Antriebsriemen & Kits

Technische Information für die Werkstatt

ERGÄNZENDER EINBAUHINWEIS

Vereinheitlichung von Wasserpumpen

Neue Wasserpumpe	Merkmale
► 1 987 949 790	Gehäuse ohne Ecke

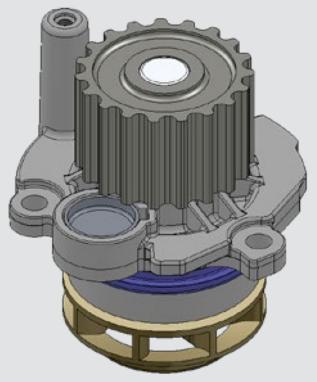
Laufrad mit 8 Schaufeln, durch unterschiedliche Schaufelwinkel geringere Kavitation.

Mechanische Dichtung aus Siliziumkarbid

Die neuen Wasserpumpen-Kits werden mit der neuen Wasserpumpe Bosch-Bestellnummer 1 987 949 790 ausgeliefert.
